Product Change Notification

Date Issued :	October 31, 2024	PCN Number :	516053
Reason for Change :	Capacity change or tool replacement		
Description of Change :	This notice is to inform you that Molex Lincoln Nebraska is going to be adding new Tooling for the production of the parts on the impacted list. There will be no impact on the Fit, Form, Function or Appearance of any product based on this tooling addition.		
Assessment of Change :	First Article Inspection SPC / Capability Studies		
Planned Implementation Date :	May 02, 2025		
Customer Sample Availability Date:	February 21, 2025		
Last date to request Samples by Customer :	January 10, 2025		
Please note if Samples are not requested as per Customer Samples Request date, it may take additional 4-6 weeks to arrange Samples.			
Traceability Code Markings / Date :	Product made after planned implementation date can contain the change

Mini-Fit Sigma Terminal Position Assurance (TPA) Retainer

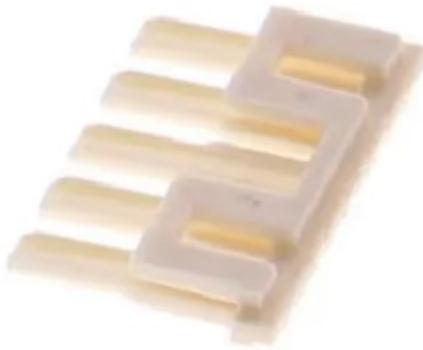
- To ensure continuous product quality and delivery, Molex Lincoln, Nebraska is adding a new tool for production of the Mini-Fit Sigma TPA Retainer.
- There is NO impact to product Fit, Form, Function, or Appearance for the components from the new tooling or to the finished goods.
- Part Numbers Impacted
 - See attached list
- Samples and Qualification Reports
 - Samples available upon request after date shown above
 - Qualification Reports available upon request after March 28, 2025
 - Qualification Reports need requested by January 10, 2025
 - Please note if Qualifications are not requested by the January 10, 2025 date, it may take additional 4-6 weeks to arrange for Qualification data to be available.
- Questions/concerns contact your Molex Account Manager
